Access Compliance Report

Public Rights-of-Way

Intersection ID: 10458	Main Street: KESWICK_AV	Cross Street: GRIMES_ST	Location:	N
ADA ID: 0323D94B6752	Ramp Type: Perp	Initial Pass/Fail: Fail	Overall Compliance: No	Severity Score: 10
Codes/Mitigation Info/Possible Solution		Field Measurements/Component Compliance

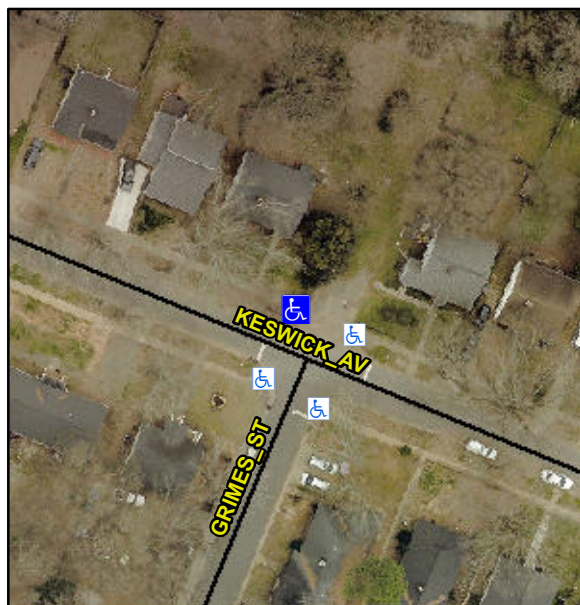
Not Found, R304.5.1, R304.5.3

Compliance	Description	Data	Compliance	Description	Data
N/A	Ramp Length (in)	51.0	Yes	Ramp Slope (%)	7.8
No	Ramp Width (in)	36.5	No	Ramp XSlope (%)	2.2
N/A	Flare Type LT	N/A	N/A	Flare Type RT	N/A
N/A	Flare Slope LT (%)	N/A	N/A	Flare Slope RT (%)	N/A
N/A	Flare Traversable LT?	N/A	N/A	Flare Traversable RT?	N/A
N/A	Landing Length (in)	N/A	N/A	DWS Provided?	N/A
N/A	Landing Width (in)	N/A	N/A	DWS Contrast?	N/A
N/A	Landing Slope (%)	N/A	N/A	DWS Length (in)	N/A
N/A	Landing X Slope (%)	N/A	N/A	DWS Full Width?	N/A
N/A	Landing Curb? (Y/N)	N/A	N/A	DWS Offset (in)	N/A
N/A	Shared Landing?	N/A			
N/A	Gutter Ponding?	N/A	N/A	Gutter Slope (%)	N/A
N/A	Gutter Lip Ht (in)	1.0	N/A	Gutter X Slope (%)	N/A
N/A	Painted X Walk1?	No	N/A	Painted X Walk2?	N/A
	X Walk 1 Direction	To SE		X Walk 2 Direction	N/A
N/A	X Walk 1 Width (in)	N/A	N/A	X Walk 2 Width (in)	N/A
	X Walk 1 Slope (%)	5.3		X Walk 2 Slope (%)	N/A
	X Walk 1 X Slope (%)	0.0		X Walk 2 X Slope (%)	N/A

Remove & Replace Entire Ramp.
